Record of Executive Business and Chief Executive's Order

Reg. Reference: SDZ22A/0011 **Application Date:** 02-Aug-2022
Submission Type: New Application **Registration Date:** 02-Aug-2022

Proposed Development: The proposed primary school will extend to c3,355sq.m will be 2 storeys in height and will comprise 16 no. classrooms with an additional 2 classroom Special Educational Needs Unit; a General Purpose Hall and all ancillary teacher and pupil amenities and facilities. The proposed development also provides for hard and soft play areas, including 2 no. outdoor ball courts, bicycle parking, staff car parking, vehicle drop off and set down areas. Photovoltaic Panels (PV) are proposed on roofs in addition to EV Charging Points and a packaged Biomass heating plant. The proposed development also provides for all Landscaping and boundary treatments and all associated site development works. Access to the site will be via a new junction and access road off Thomas Omer Way. The new access road will run south off Thomas Omer Way and then west into the site. The proposed access road is in accordance with the Clonburris Strategic Development Zone (SDZ) Planning Scheme and incorporates publ

Figure 1 link street.

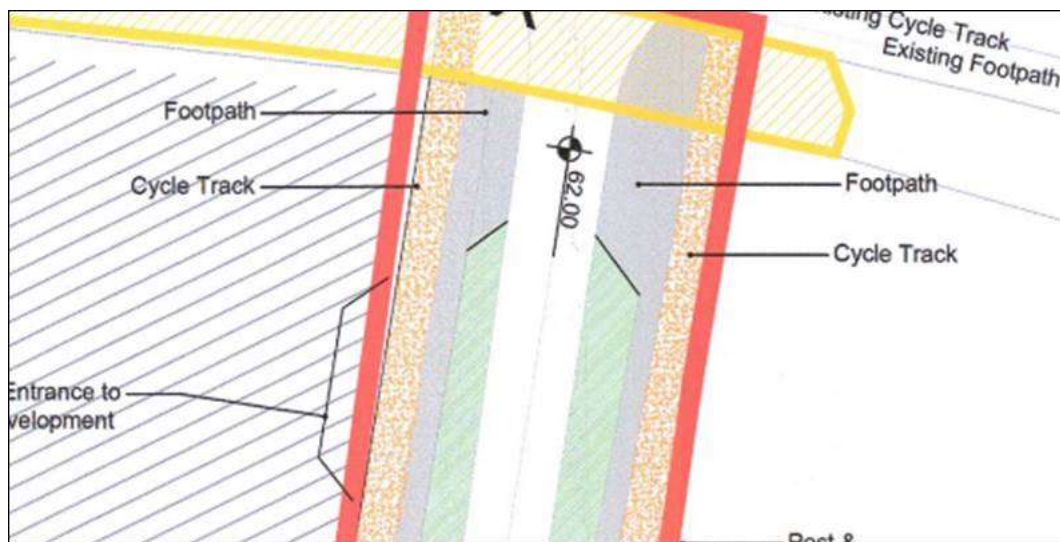
The entrance road should match the street layout as described in the SDZ, the cycle lanes and footpaths do not match the layout out for a link street. The cycle track is outside the footpath. No dimensions or cross section have been provided.

There is provision for future road connection to the south linking with the greater Clonburris developments. This road should be constructed in its entirety to the boundary to prevent ransom strips at a future date. Entrance locations to the future development area at the centre have been indicated although the southern potential access is located within the drop off area.

5. The applicant is requested to submit a revised layout showing the location of refuse collection points.
 6. The applicant is requested to submit a revised layout of not less than 1:200 scale showing the cross section of the access roads, ensuring they confirm to the layout described in the Clonburris SDZ masterplan.
